Re: Second Submission Review – Murphy Creek / Harvest Ridge PA - Site Plan and Plat
Application Number: **DA-1250-54**
Case Numbers: **1995-2002-10; 2021-4019-00; 2021-3039-00**

Second Submission Review

Figure 4.6-3: Alternate-load Garage

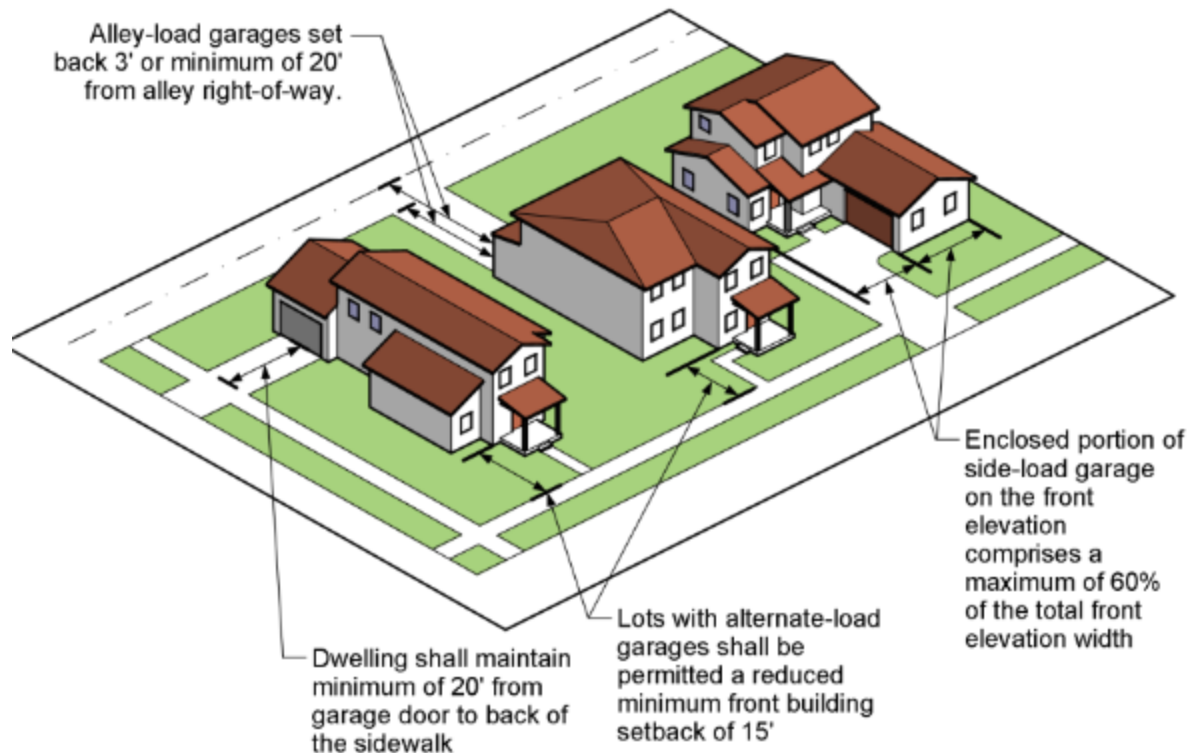
- 3I. An adjustment will need to be requested for the rear setback from section 4.6-3. Alley loaded setback must be set back 3' or a minimum of 20'.
